Application number 17/00997/CONDIT for discharge of Condition 6 concerning drainage for planning permission 15/02107 for the relocation of the Phoenix Gym to land north of Longlea, Fifield Road, Fifield, Berks

Phoenix Gym - Condition 6 - SUDS

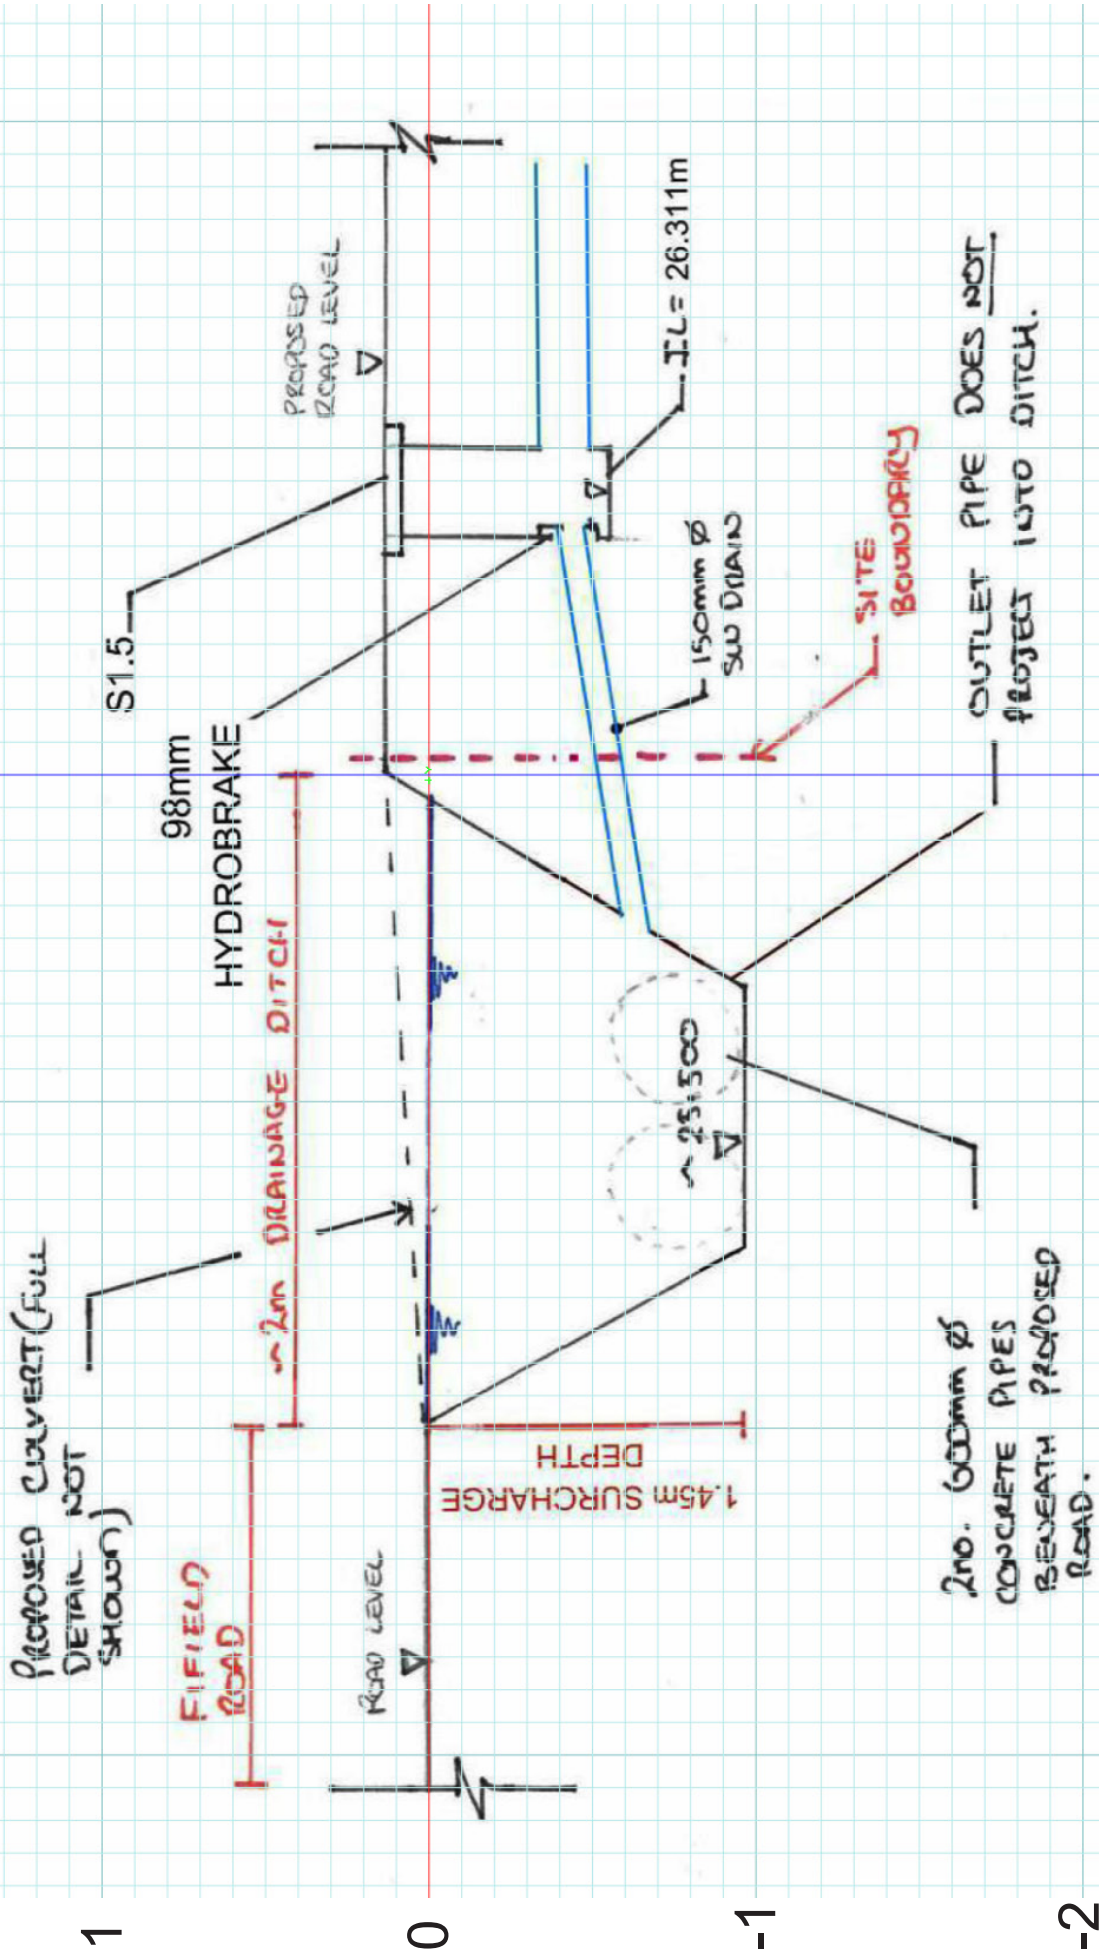
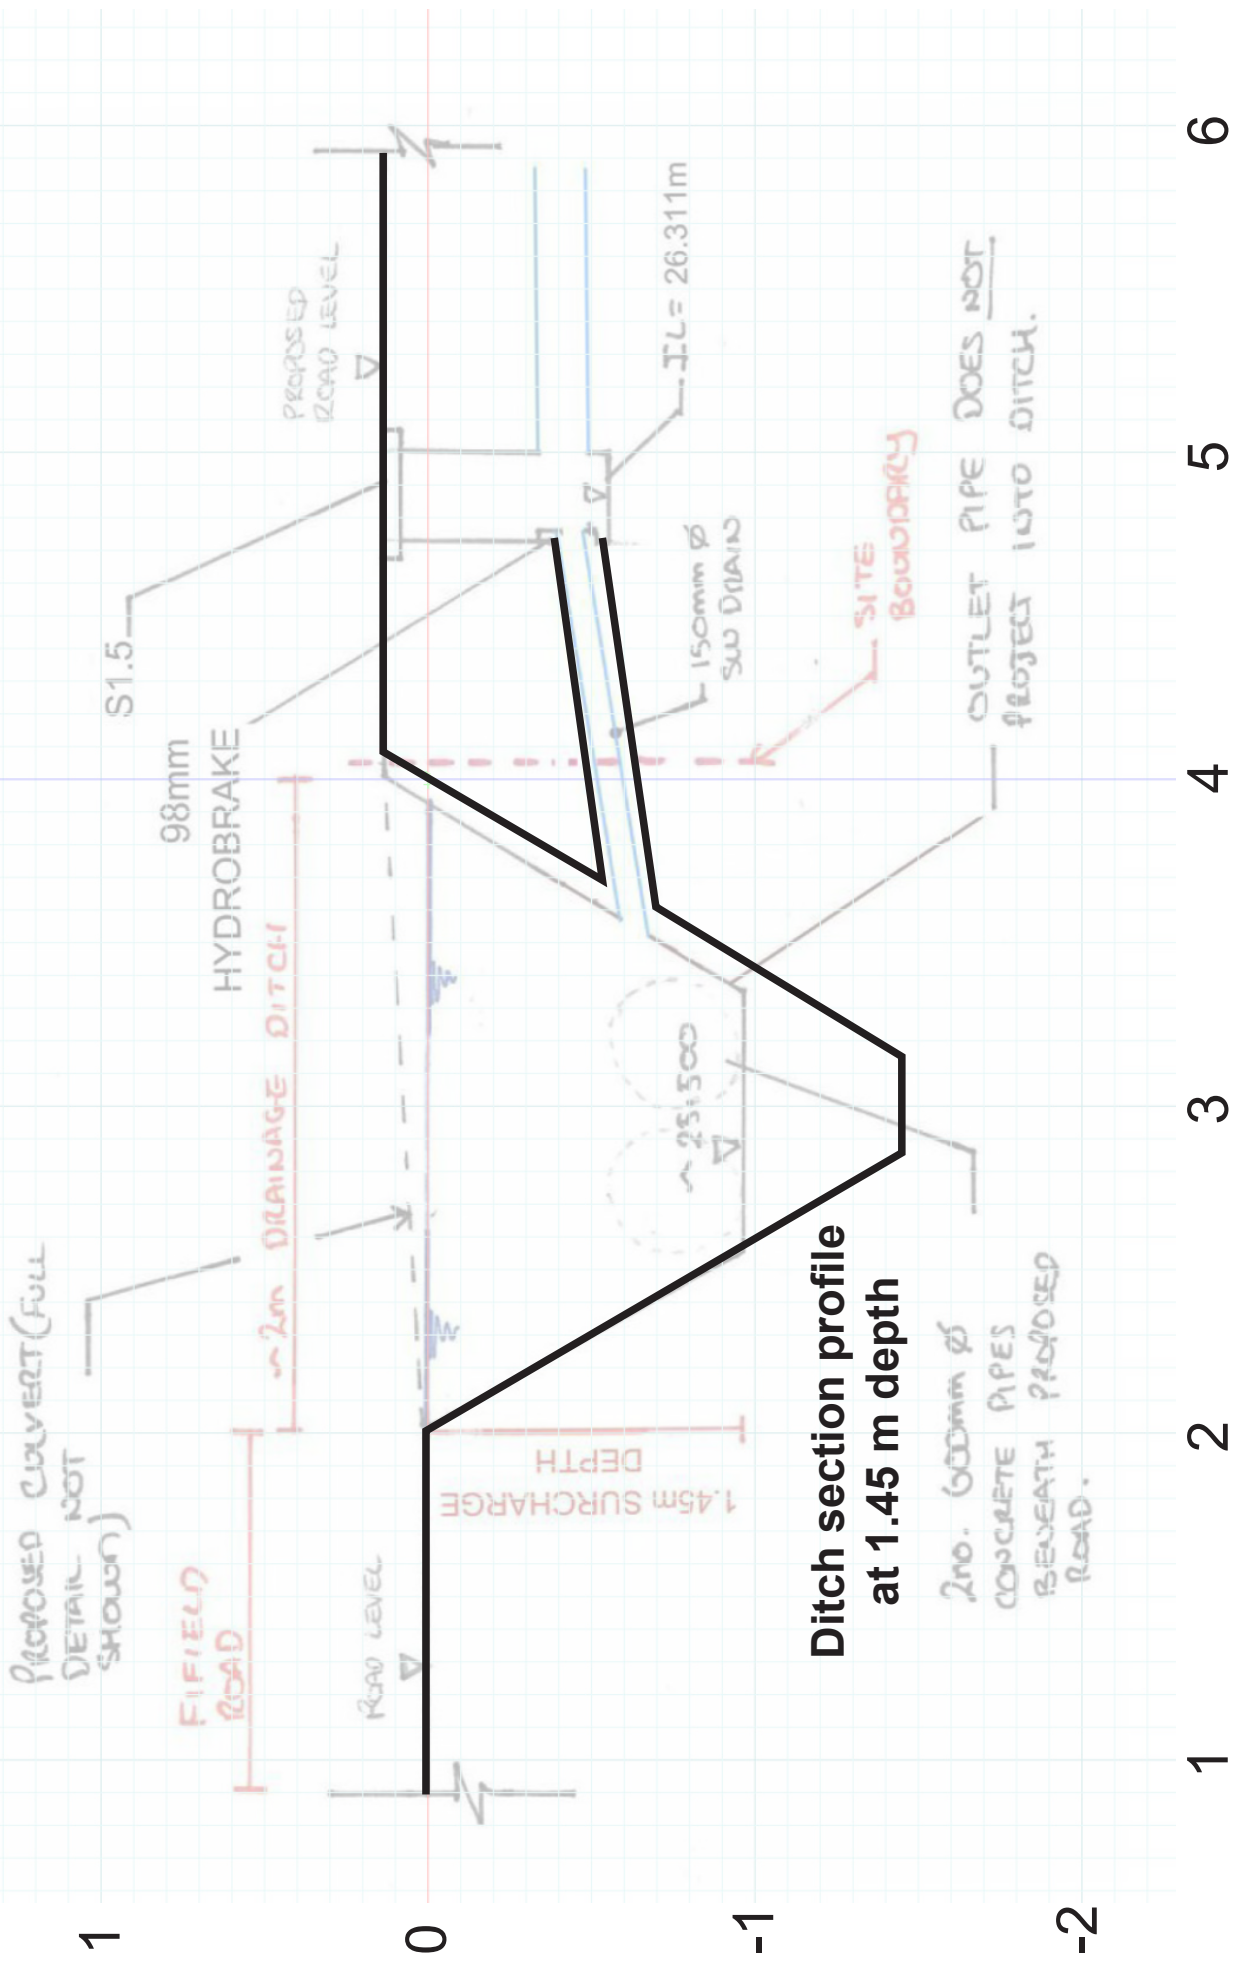
The ditch cross section diagram is emphatic that the outflow pipe will not protrude into the ditch so there is no possible obstruction of flow, thus avoiding need to obtain consent.

The same diagram suggests the use of 2 x cement pipes to form a bridge for the site entrance. This concrete obstruction across ditch makes encroachment of 6 inch pipe seem trivial by comparison. Surely this would form a very significant obstruction to the flow when the ditch is full ? ... or even 66% full ?

2no. 600mm ϕ CONCRETE PIPES BENEATH PROPOSED ROAD.

OUTLET PIPE DOES NOT PROJECT INTO DITCH.

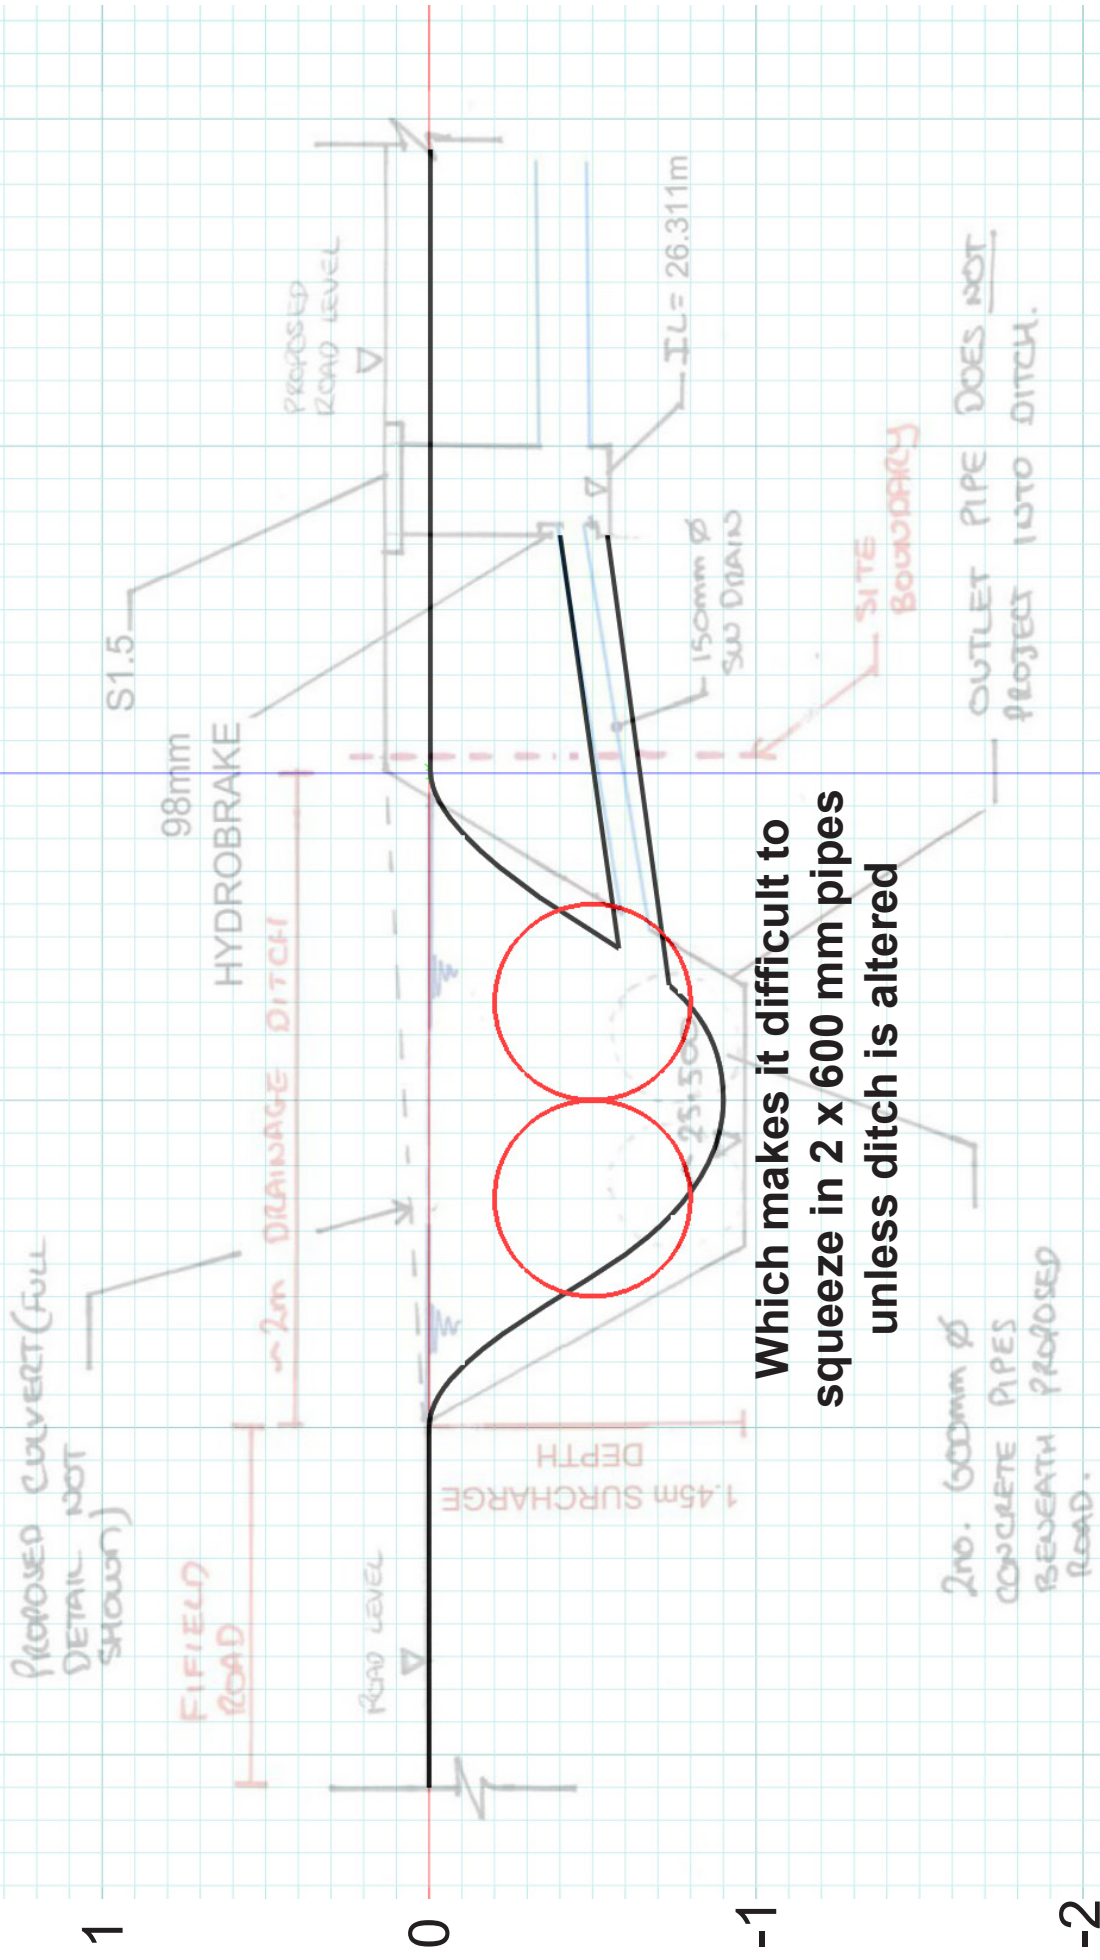
Which makes it difficult to squeeze in 2 x 600 mm pipes unless ditch is altered

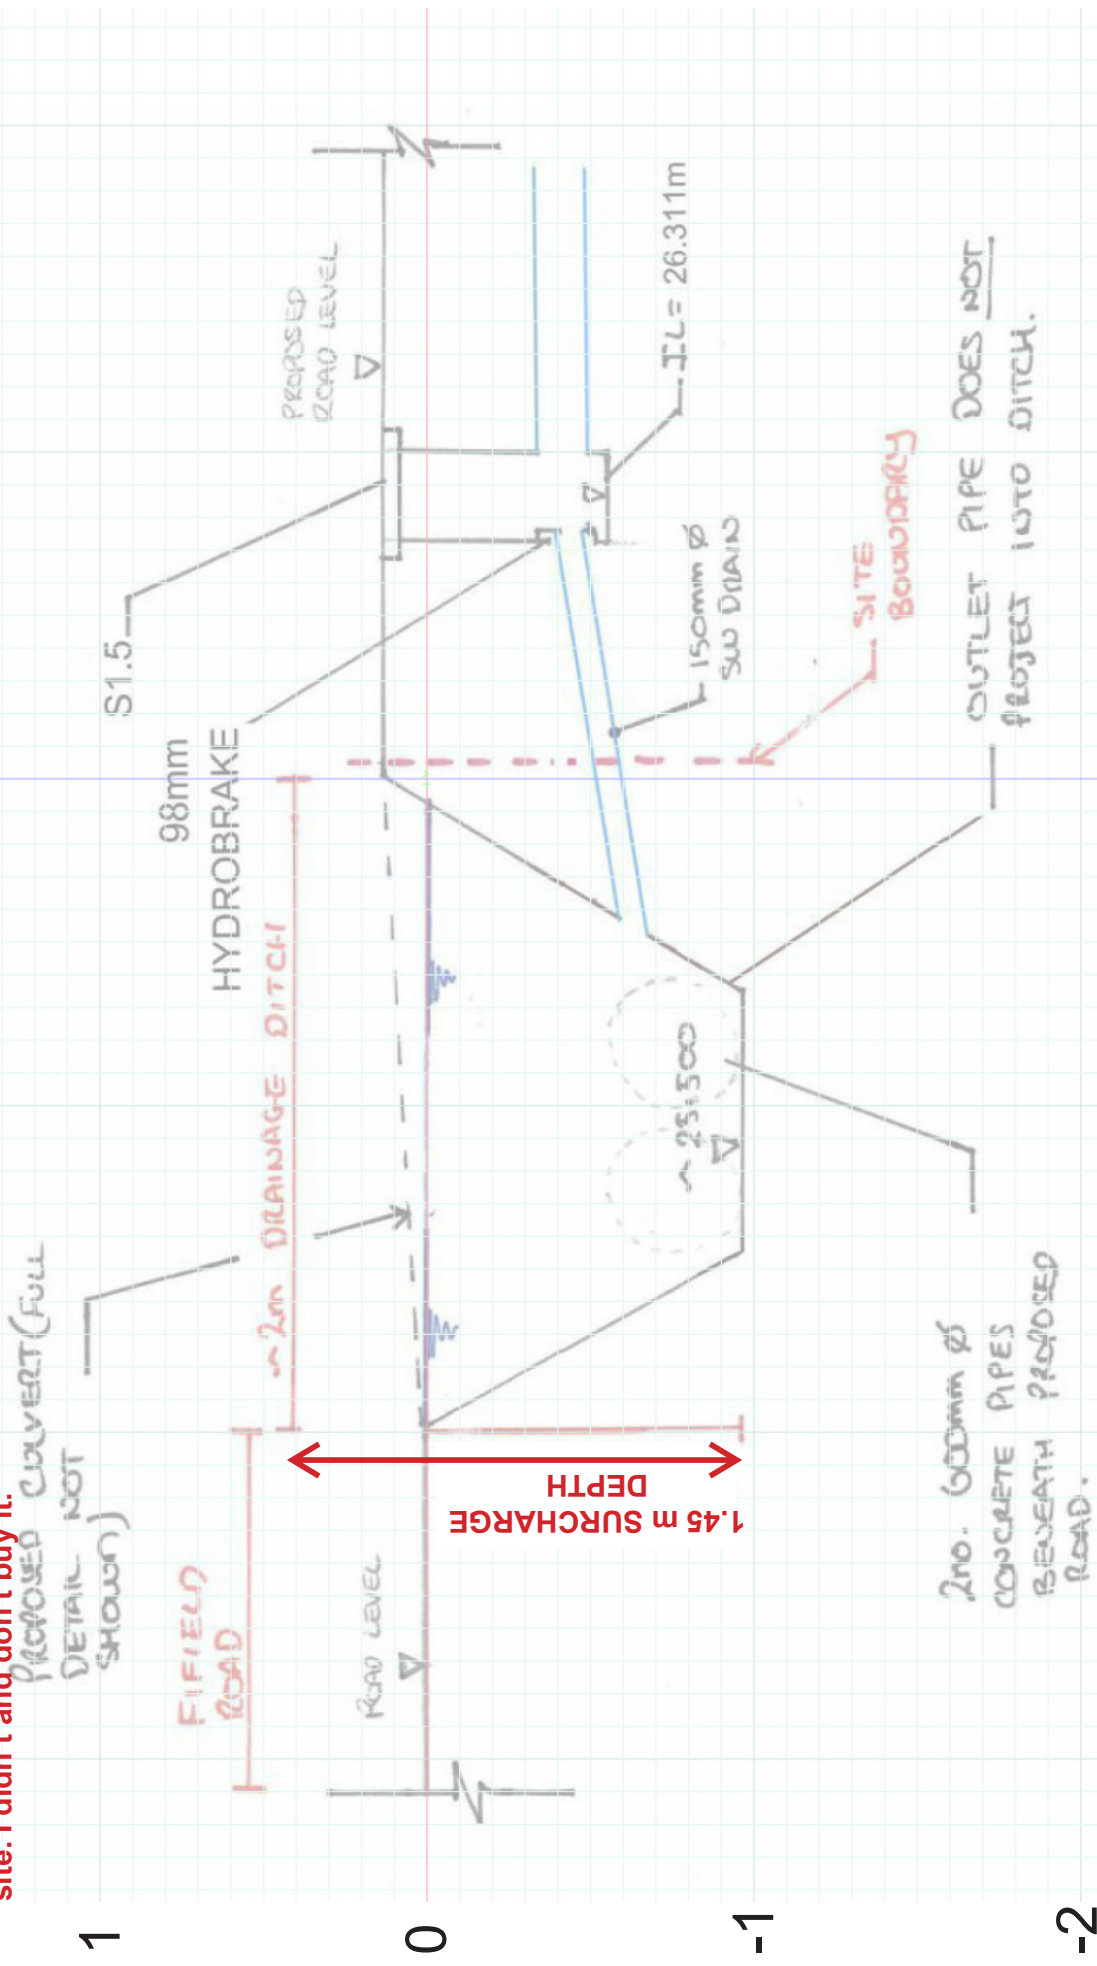
It is not easy for a lay person to understand the reason given for allocating an incorrect dimension to the ditch.

Could we please have an explanation of how this distortion serves any useful purpose ?

Mr Rowe's explanation of the "ditch depth" error. He says it's a simple mis-drawing of the diagram and that the figure used is simply to ensure a set of modelling circumstances where nothing can leave the site. I didn't and don't buy it.
